SB369H-256
SB369E-112
SB500N-052

SERVICE BULLETIN

DATE: 30 JUNE 2015

EXCHANGE OF ENGINE BAY DOOR LATCH ASSEMBLIES WITH MISSING LOCKWIRE HOLE

Figure 1. Location of Latch Assemblies

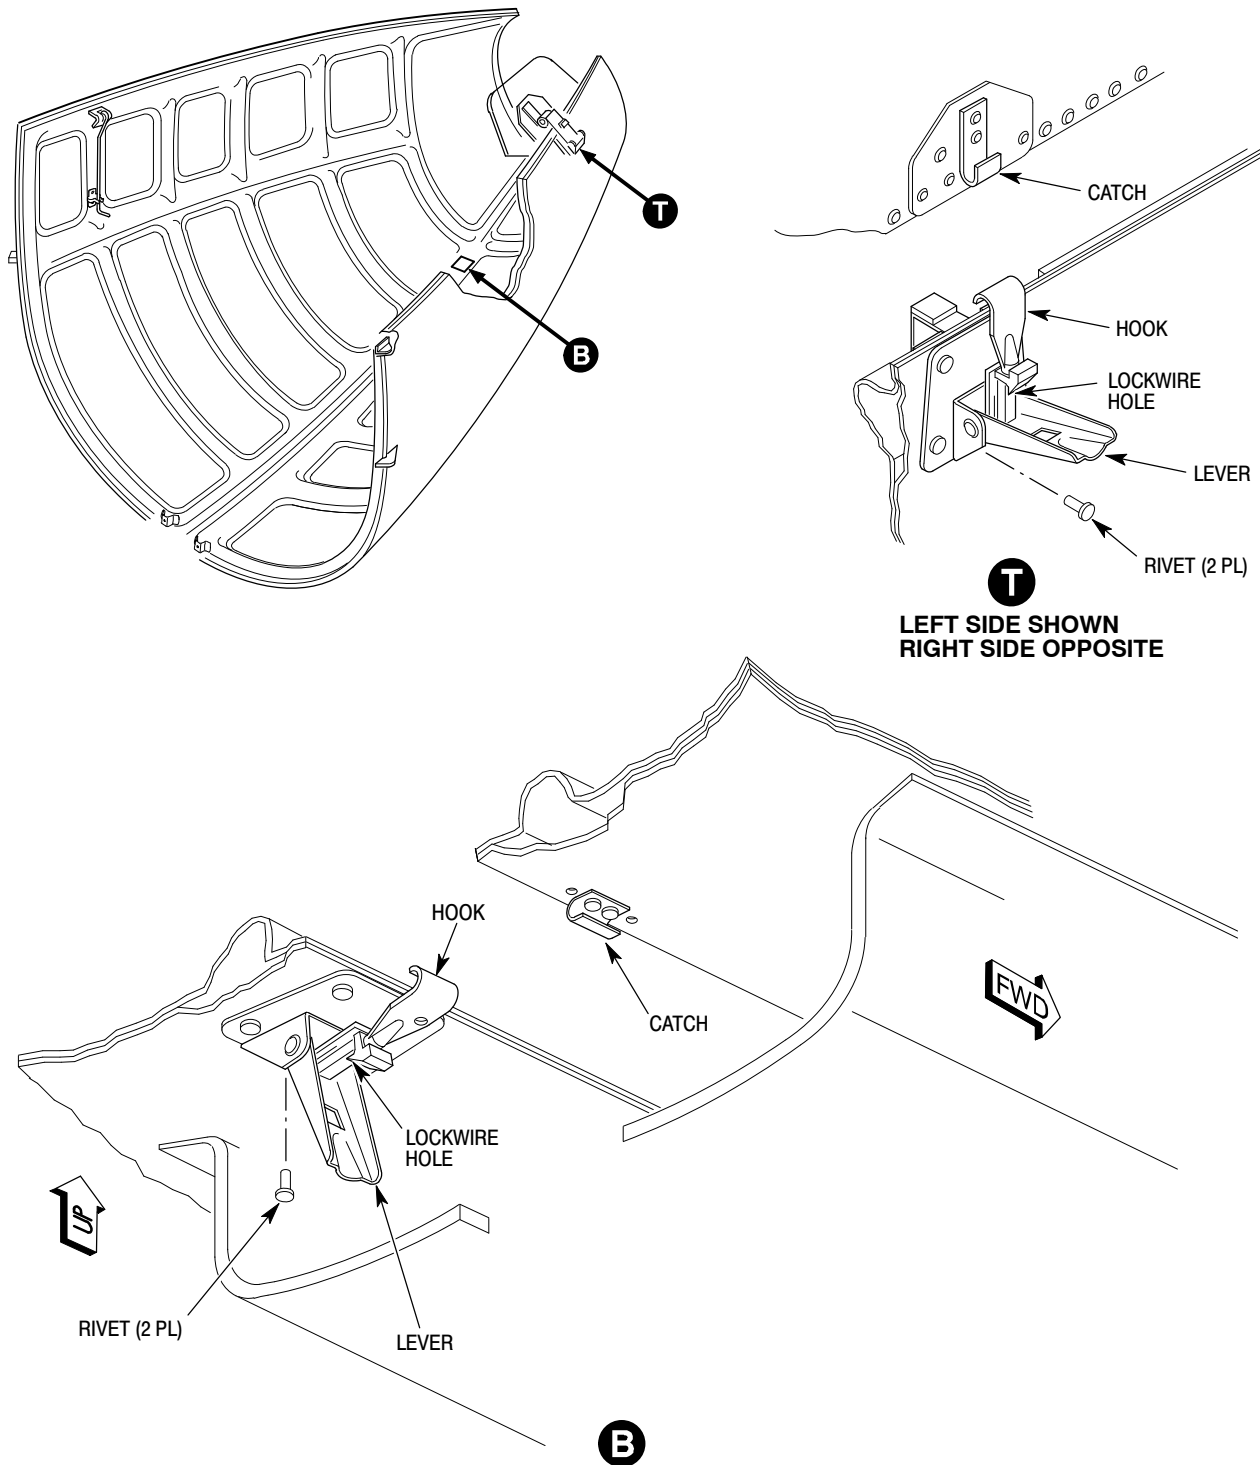
(Ref. Figure 1)

- (1). Do an inspection of helicopter maintenance records for the installation of V951L04-1X38P latch assemblies.
- (2). Do an inspection of helicopters for installed V951L04-1X38P latch assemblies.
 - (a). The V951L04-1X38P latch assemblies will not have the lockwire hole.
 - (b). Tell MDHI Field Service of an incorrect latch to get the correct latch sent to you immediately.
- (3). Remove installed V951L04-1X38P latch assemblies (ref. CSP-HMI-2, Subject 52-40-00).
- (4). Send removed V951L04-1X38P latch assemblies to MDHI with an SOR.
- (5). Install correct latch assembly on the engine access door (ref. CSP-HMI-2, Subject 52-40-00).
